HITACHI MICROCOMPUTER TECHNICAL UPDATE

DATE	8 September 2000	No.	TN-SH7-252A/E
THEME	SH-4 SCI transmission usage notice		
CLASSIFICATION	<input type="checkbox"/> Spec change <input checked="" type="checkbox"/> Limitation on Use <input type="checkbox"/> Supplement of Documents		
PRODUCTNAME	HD6417750BP200, HD6417750BP200M, HD6417750F167, HD6417750F167L, HD6417750VF128, HD6417750SE167A, HD6417750SVE133A, HD6417750SVBT133A	Lot	All
REFERENCE DOCUMENTS	SH7750 Series Hardware Manual	Rev.	EffectiveDate Eternity
		1 - 4	From

Fig.1 The example of a plan in SH-4

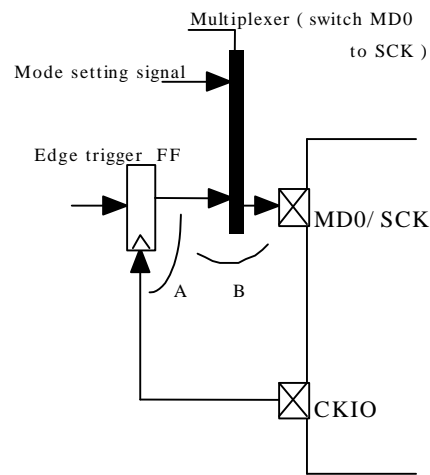
When a transmission is done using built-in SCI, a failure may occur.

A data may be transmitted twice(or more).

As shown in Fig.1, please synchronize SH-4 SCK signal using CKIO.

The minimum SCK clock cycle time in this case becomes a (peripheral clock cycle time×8).

By doing this workaround, because the timing margin of an equivalent for the synchronization of SCK terminal, TxD terminal, and RxD terminal decreases, please be careful.

Fig 2. For SCK, Input Timing of CKIO

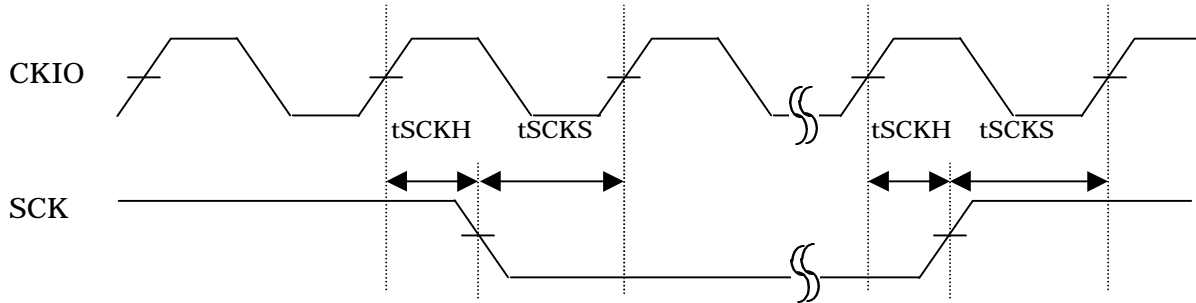
Including edge-trigger type F.F and delay of multiplexer on Fig1, which should satisfy the conditions of the timing below.
